2020 Urban Water Management Plan for
**Santa Clarita Valley Water
Agency** (Los Angeles County Waterworks District No. 36/Cooperating Agency)

Appendix I: Ground Water Management Plan

Groundwater Management Plan

Santa Clara River Valley Groundwater Basin, East Subbasin

Figure 3-2
Historical Groundwater Elevations
Santa Clara River Valley East Groundwater Subbasin

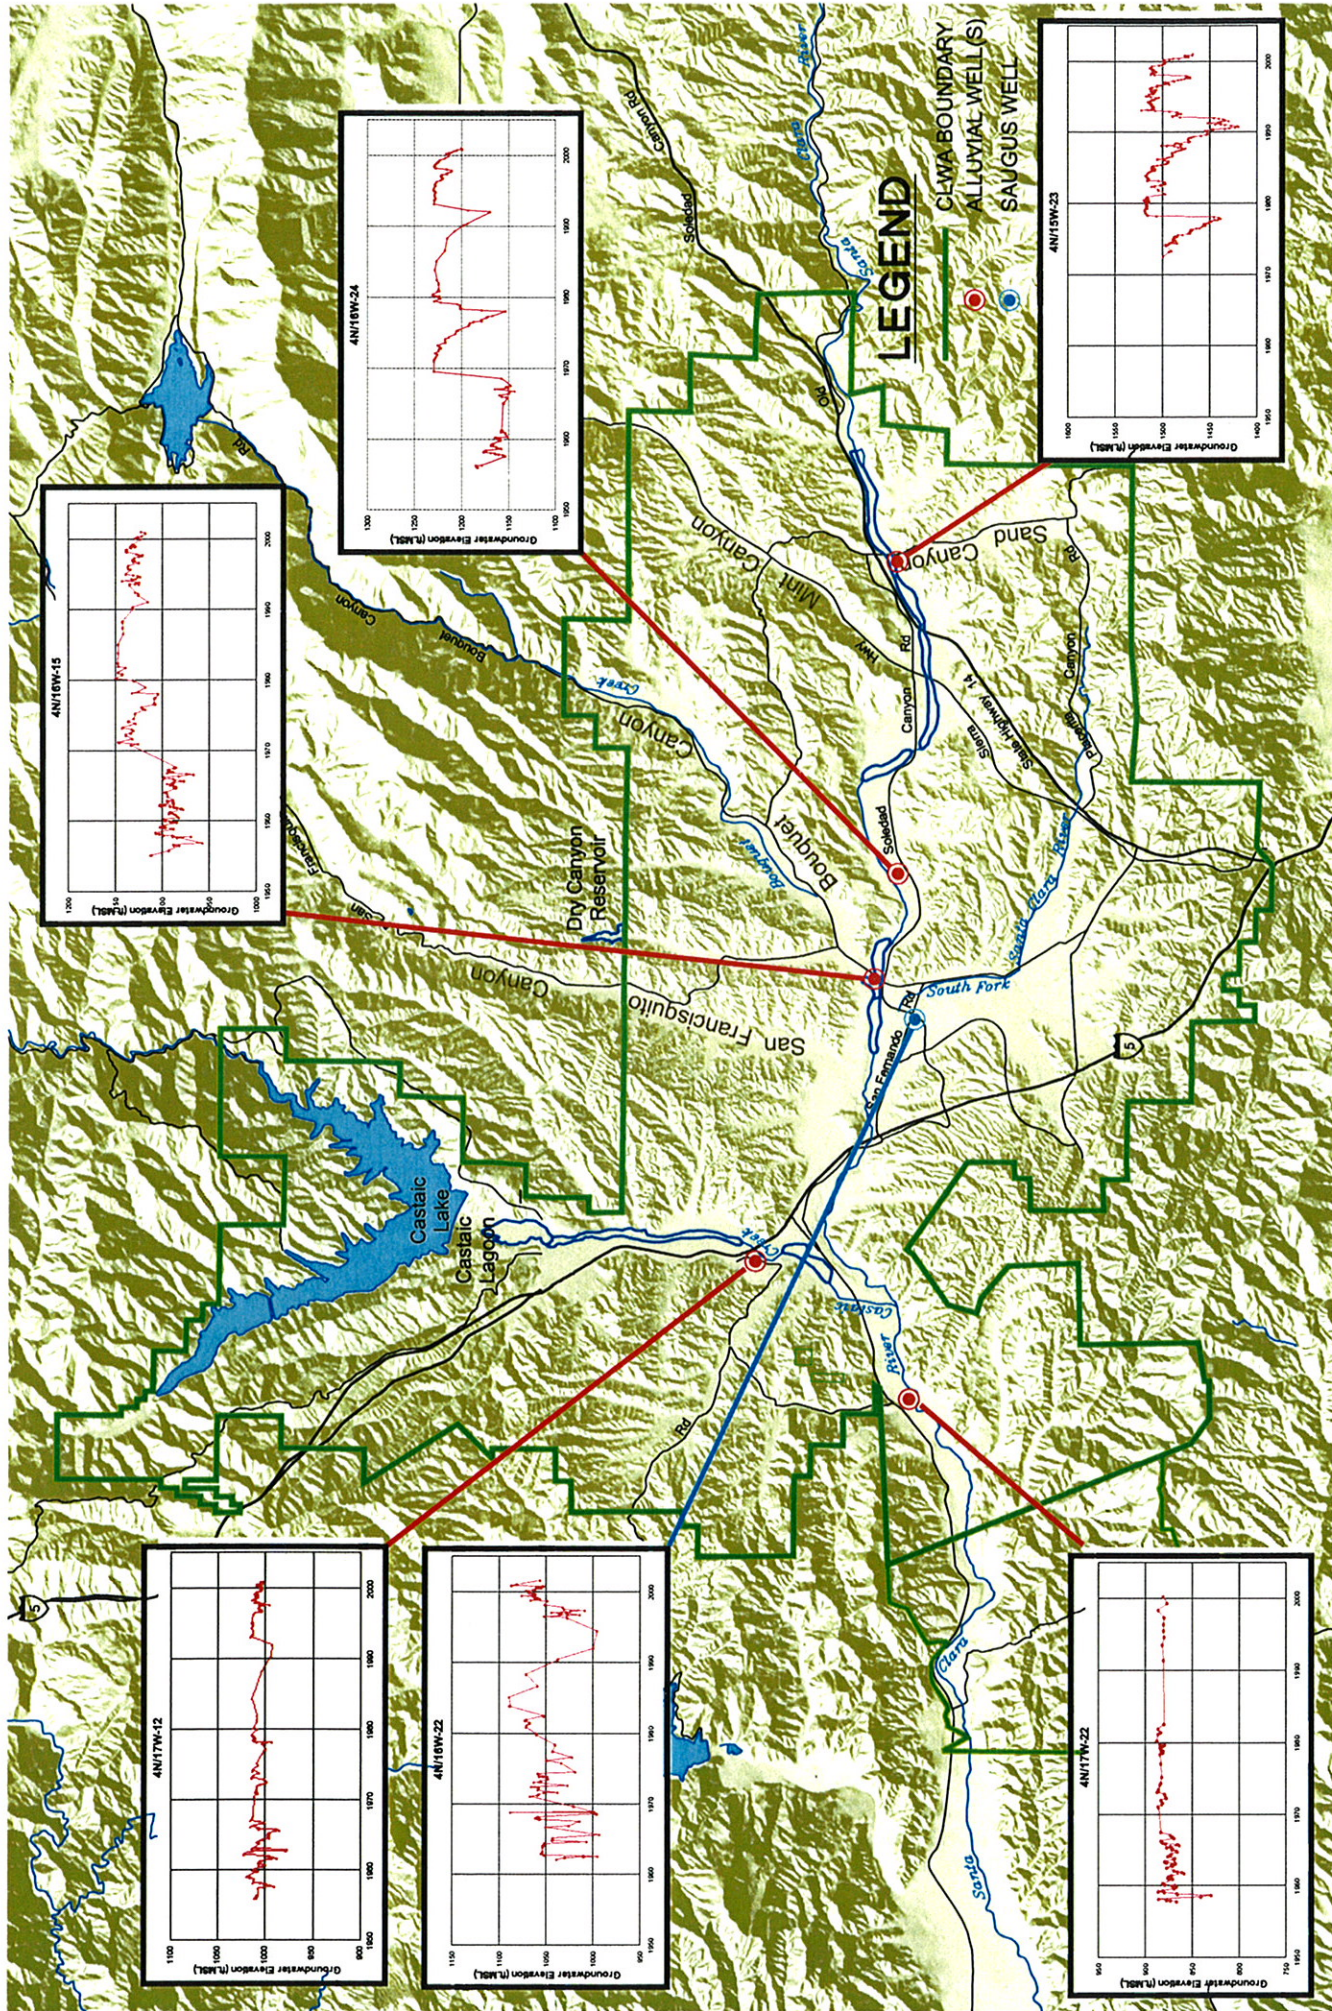
Figure 3-2. The vertical and horizontal scales associated with the hydrographs are very difficult to read. The T4N/R17W, Section 22 well, in the western arm of the Alluvial Aquifer does not show data from approximately 1983 through 1991. In previous reports and analyses, the NLF #C5 well was used for this area. This well depicted variable groundwater levels for the period from the mid-1980s to the early 1990s. Because this is the discharge area of the Alluvial Aquifer to the Santa Clara River, we need to understand the response of the system to the onset of agricultural pumping in this area in the mid-1980s. The T4N/R17W, Section 22 well does not possess the data needed to show that response;

Figure 5-1
Water Level Monitoring Well Network
Santa Clara River Valley East Groundwater Subbasin

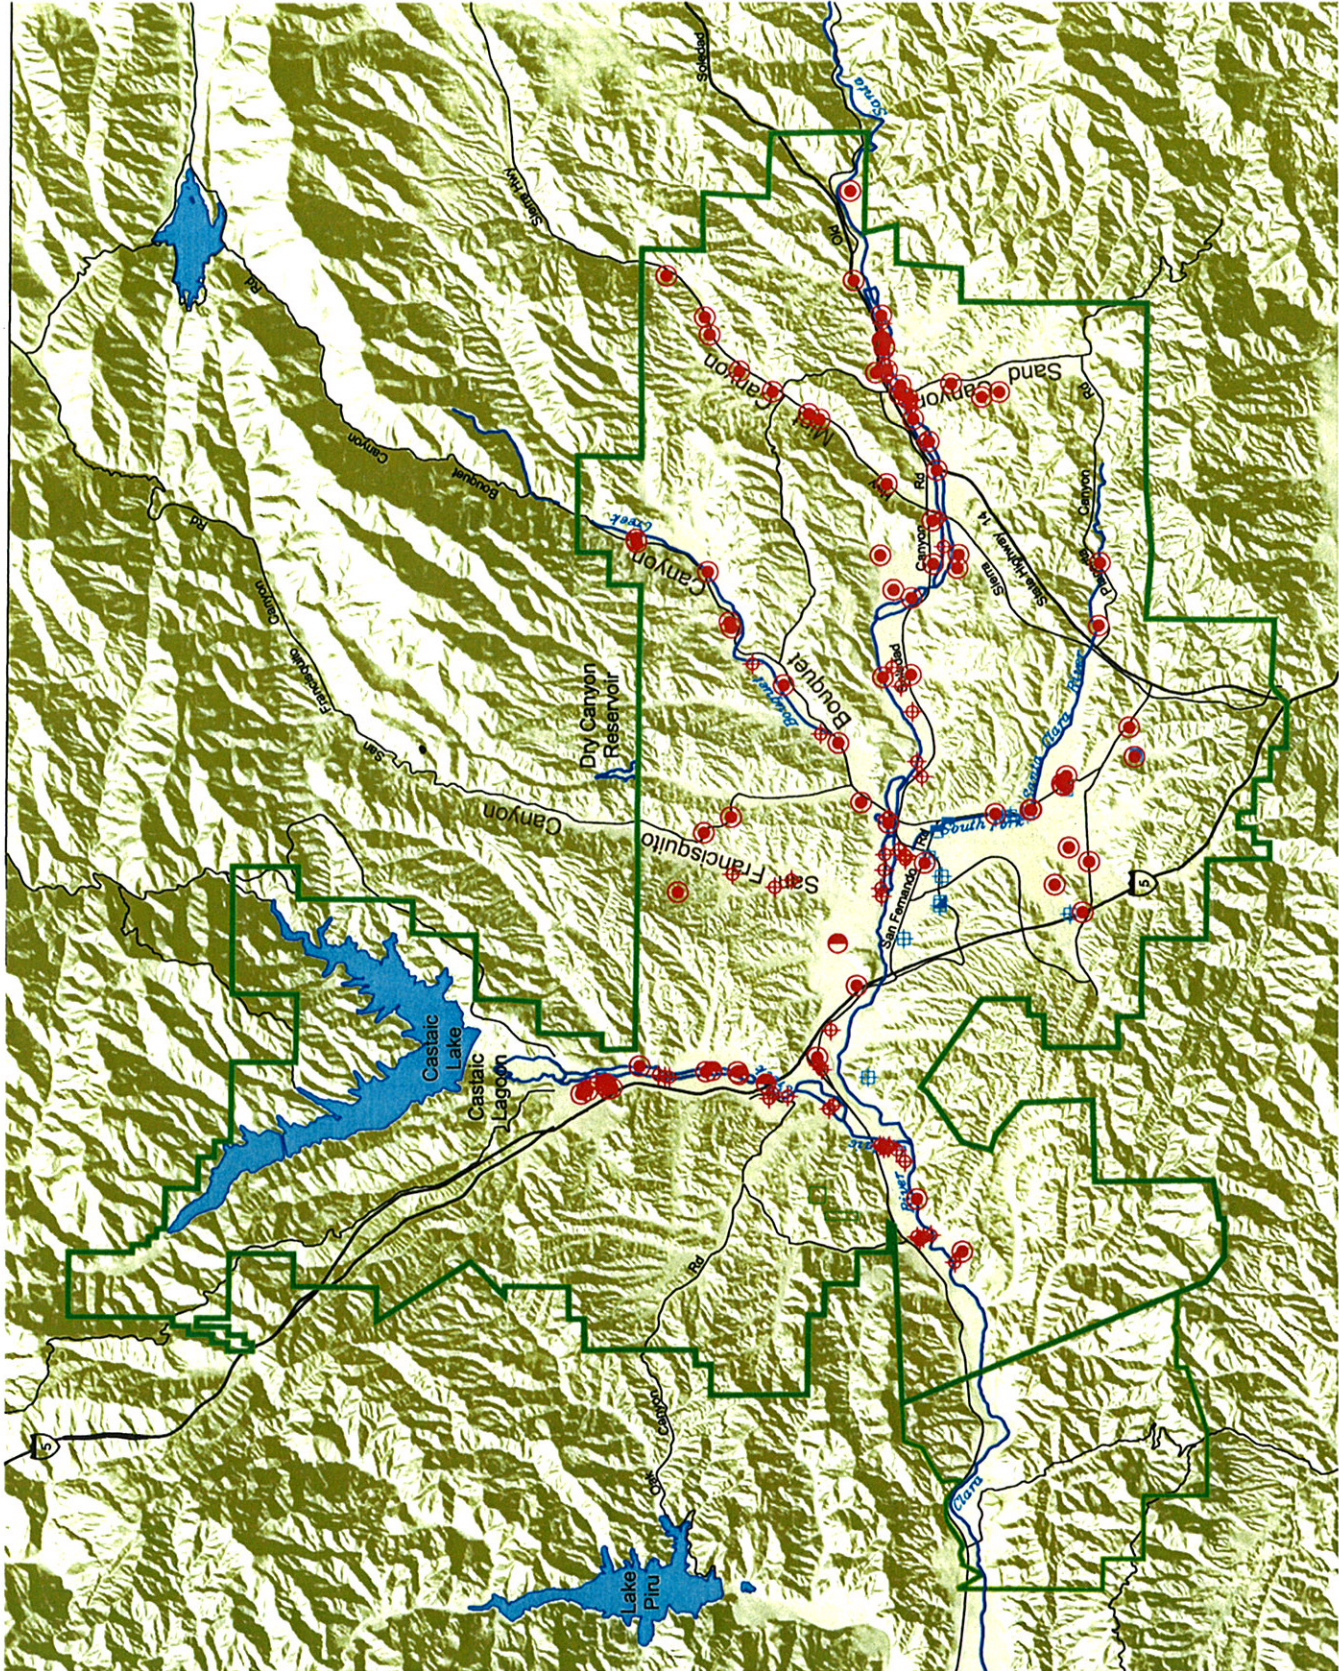
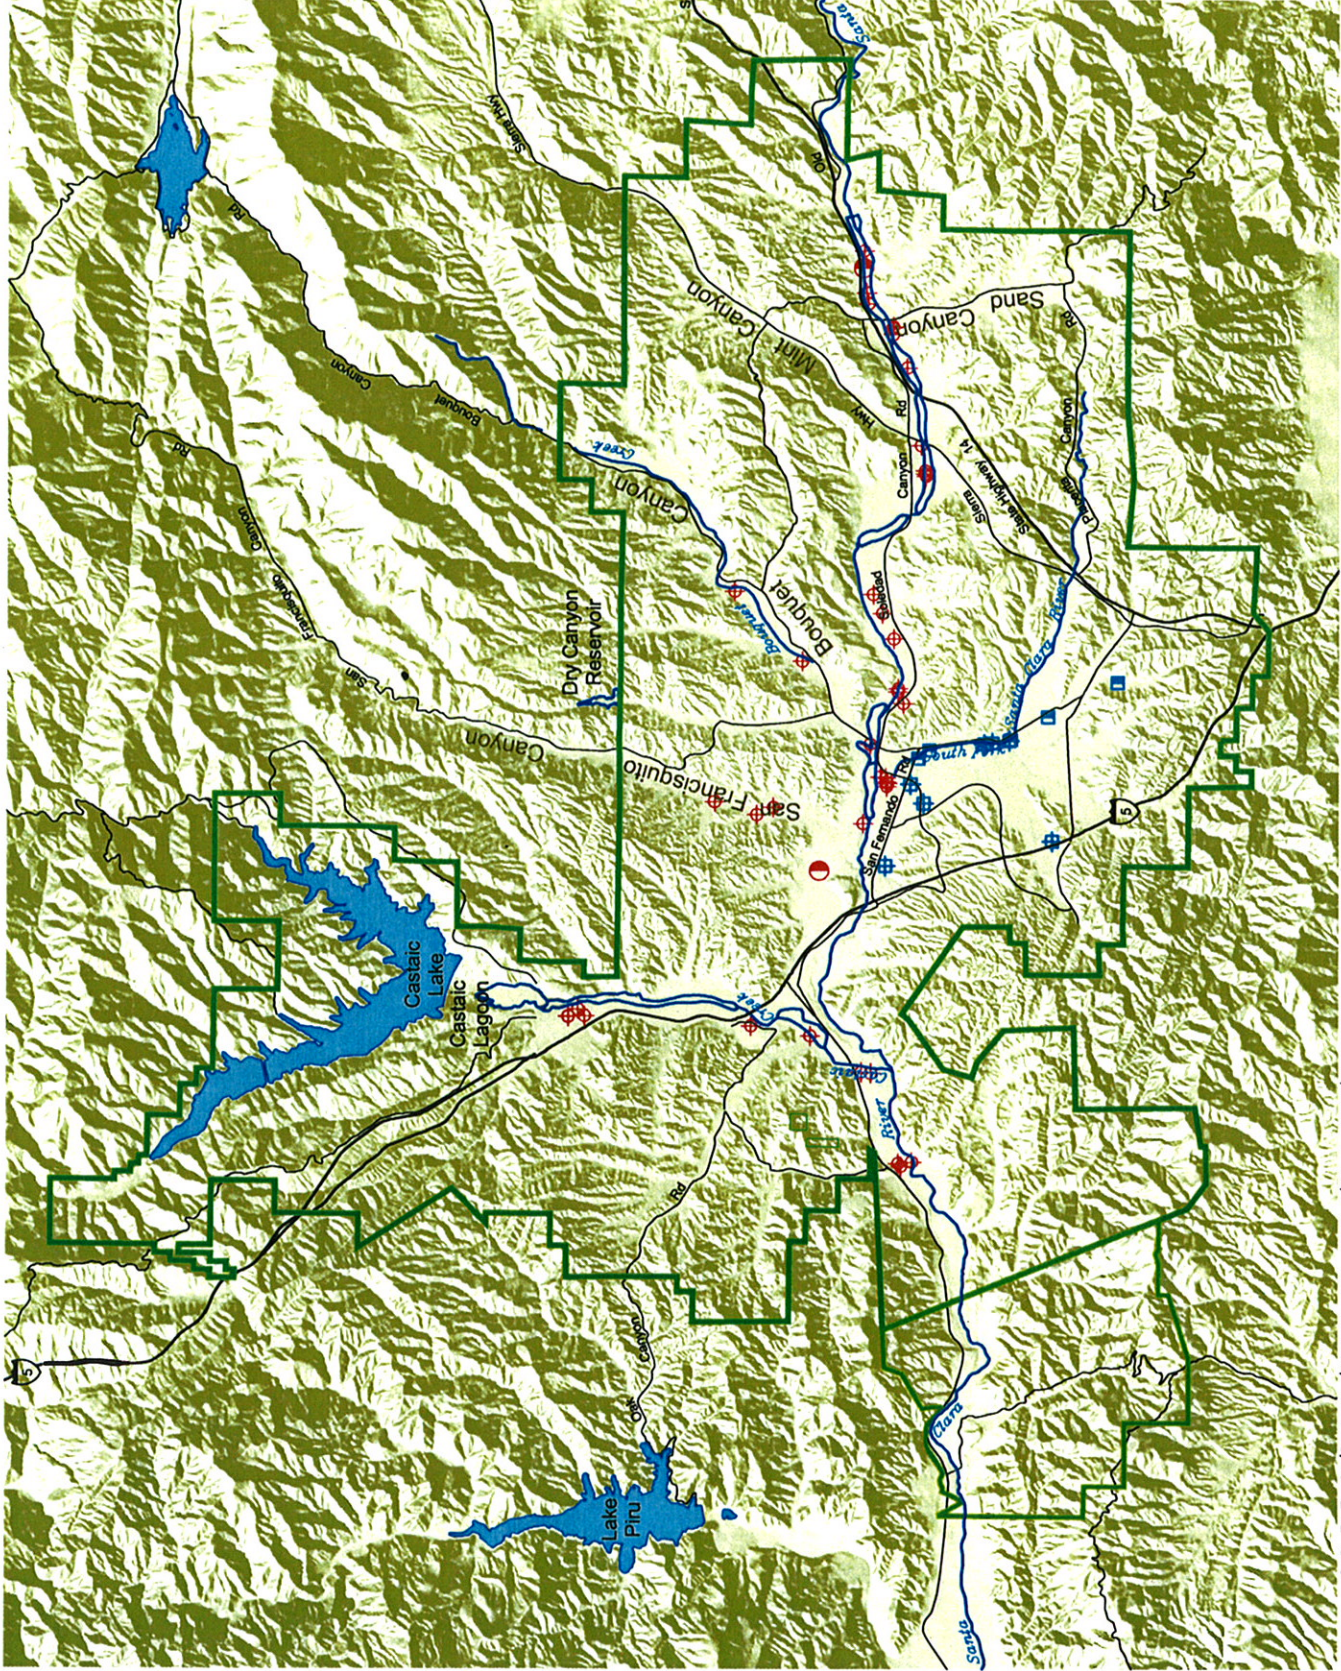
First, I commented previously on the proposed network of monitoring wells and the public availability of data. The monitoring wells in figures 5-1 and 5-2 appear to cover a wide range of the valley. However, the text on p. 27 states the network will be "mostly as illustrated in figures 5-1 and 5-2, but possibly expanded..." I hope the final network is extensive and covers all areas of the valley. Further expansion of the network would add valuable data points and should be encouraged.

Figure 5-3

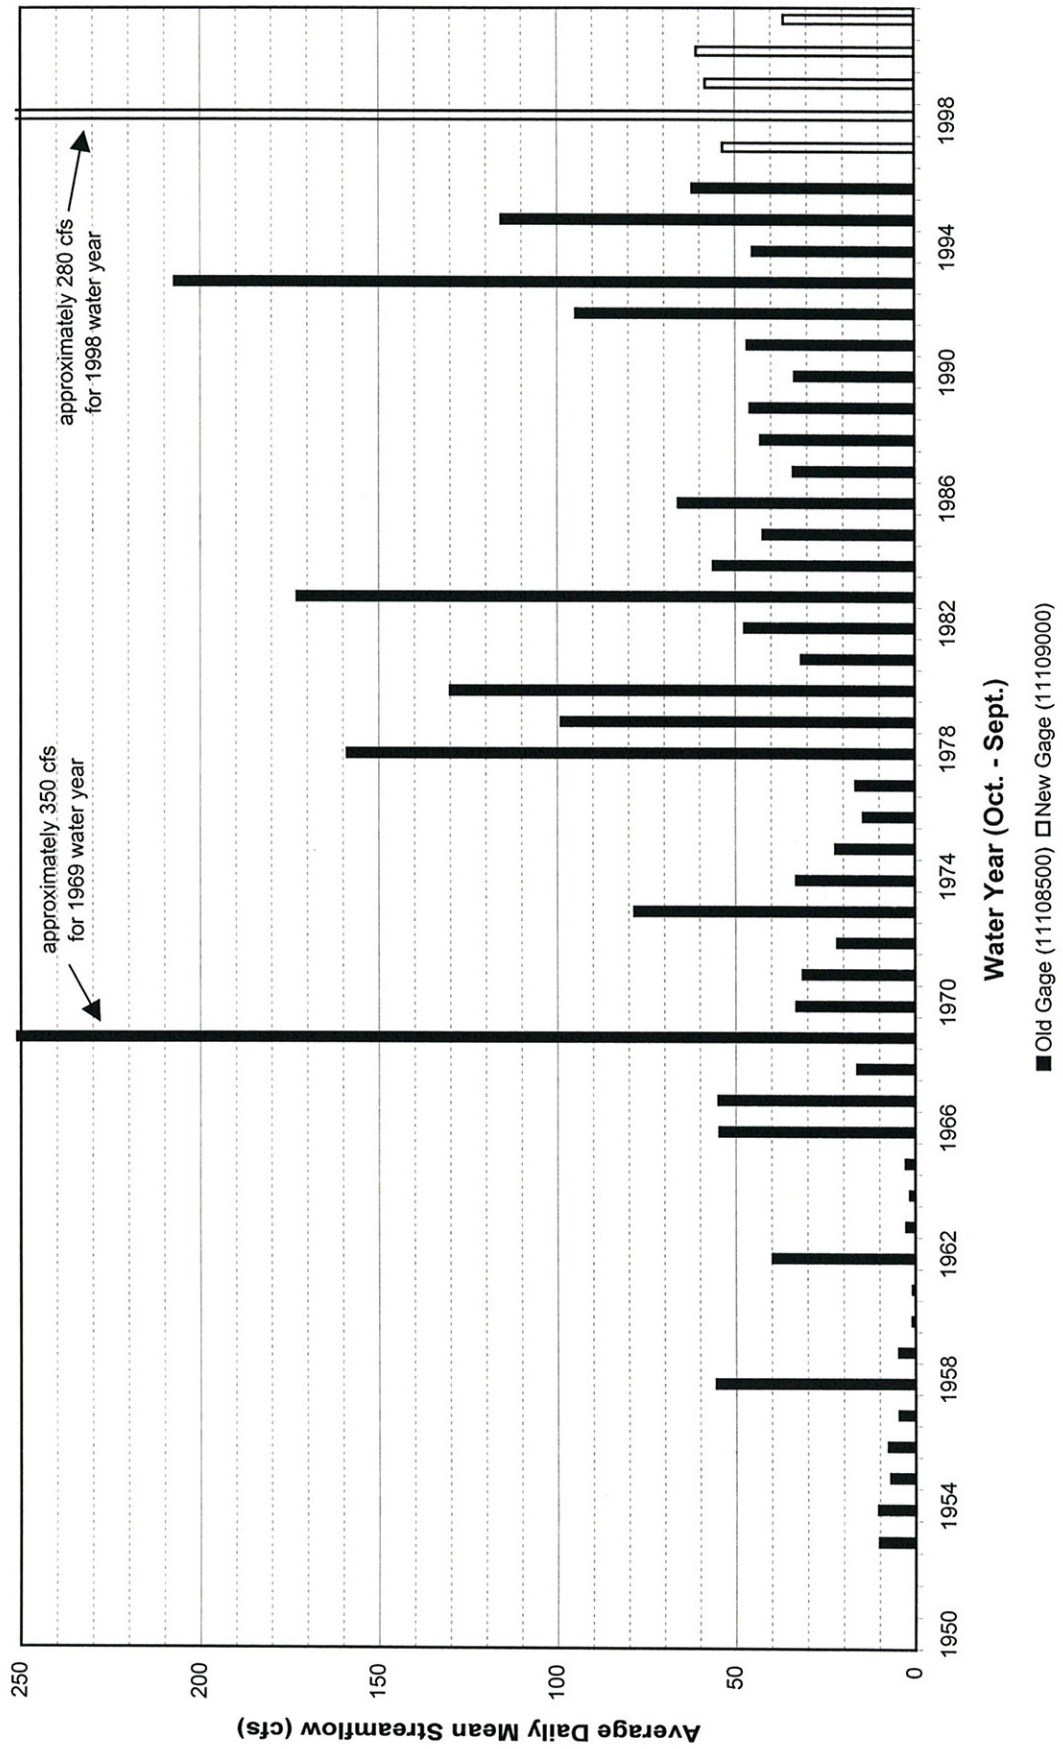
Figure 5-3. The average daily mean streamflow data appears to be shifted one year on the histogram graph. As an example to show the error, the histograms suggest that there were high flow years in 1968 and 1997. The high flow years were actually 1969 and 1998;

Figure 5-4

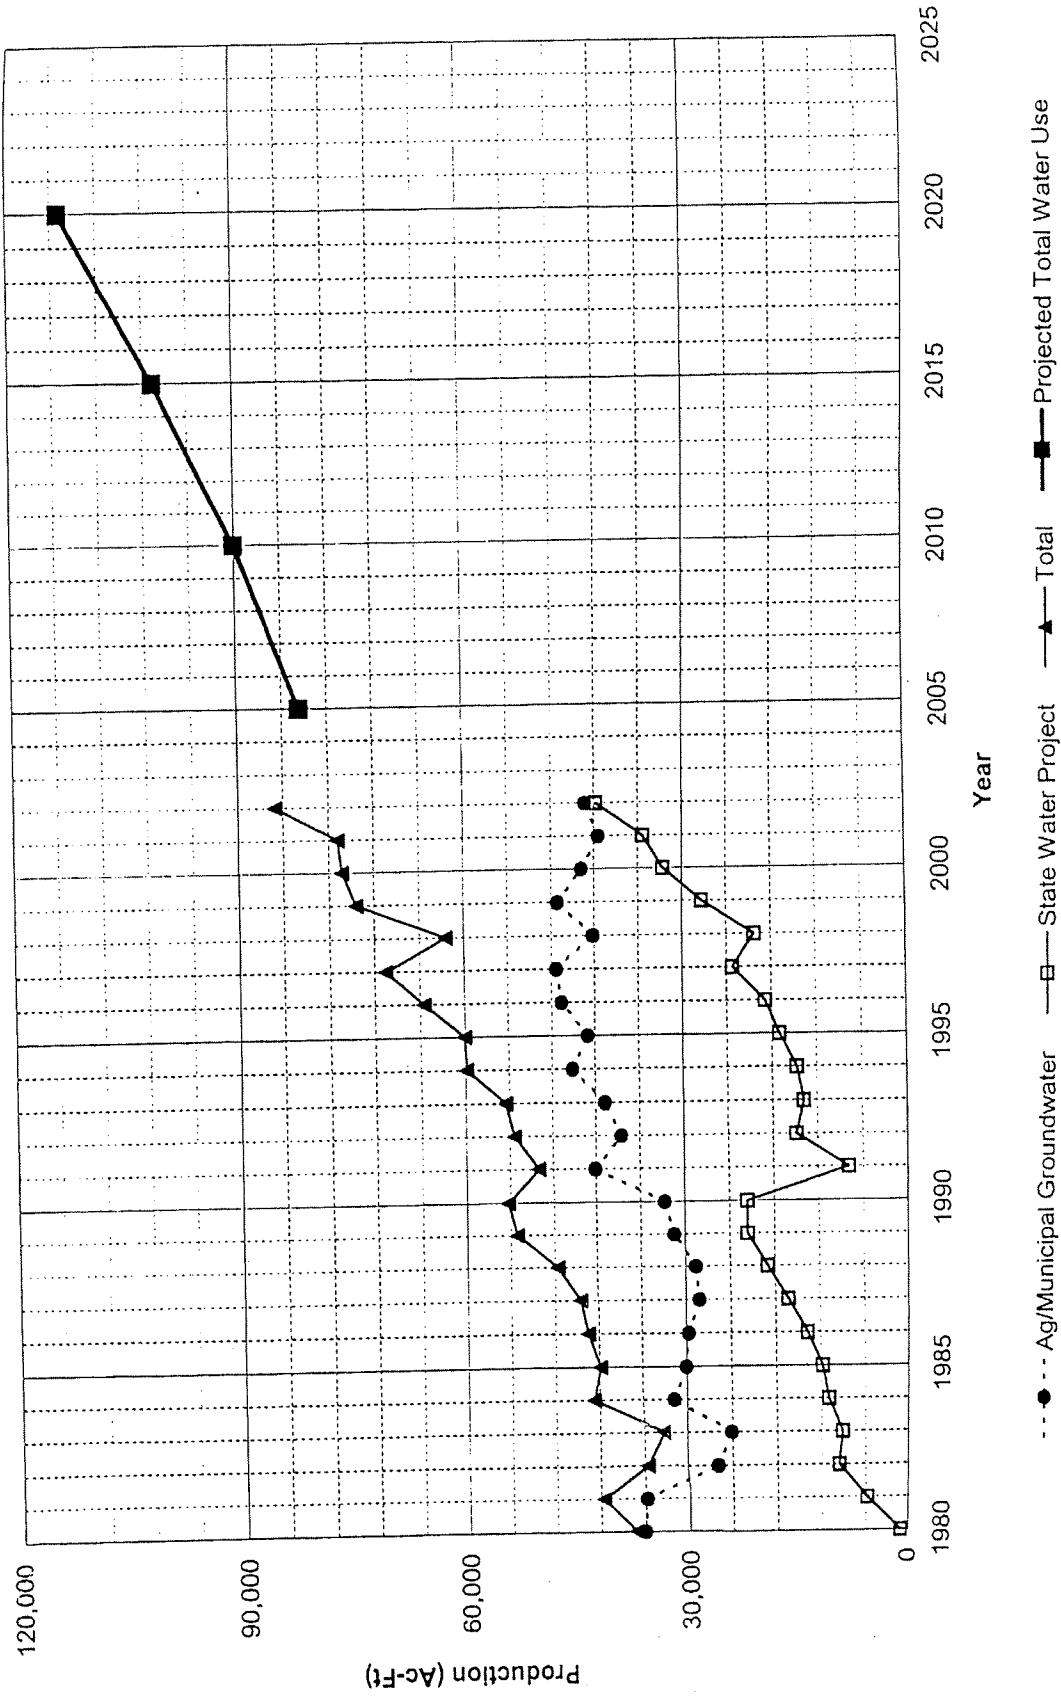
The SWP water received in 1991 is erroneous. The chart indicates 8,000 a/f. It is incorrect. CLWA only received 10% of its then allocation 54, 200 a/f. The 10% was received in January and the plant shut down in March. See Exhibit A. It should be noted that this is a state water project interruption for months, not a reduction.
